## Product Change Notification / SYST-21KRWH782

ERRATA - PIC32MX1XX/2XX/5XX 64/100-pin Family Silicon Errata and Data Sheet Clarification Revision

## PIC32MX1XX/2XX/5XX 64/100-pin Family Silicon Errata and Data Sheet Clarification

## 17. Module: I/O Port - Initial Pin State

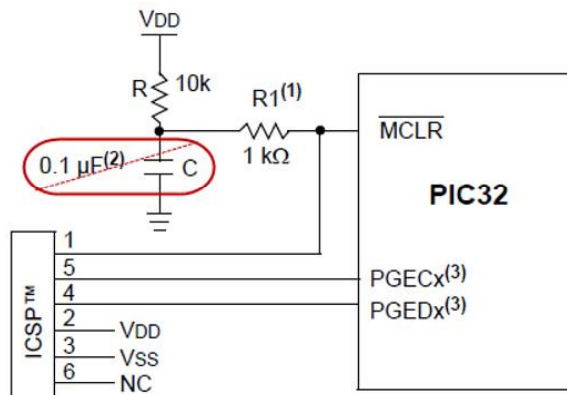
On power-up depending on the VDD ramp rate, the I/O pins can be in an active random output driving state if  $\overline{\text{MCLR}}$  is active until a BOR event.

If, not using an external reset supervisor IC or equivalent, remove the  $\overline{\text{MCLR}}$  capacitor as shown below, and retain the  $\overline{\text{MCLR}}$  Pull-up resistor.

If using an external reset supervisor IC or equivalent, increase the value of the VCAP capacitor to  $\geq 47 \mu\text{F}$  ceramic or solid tantalum capacitor with an ESR  $\leq 1 \text{ ohm}$ .
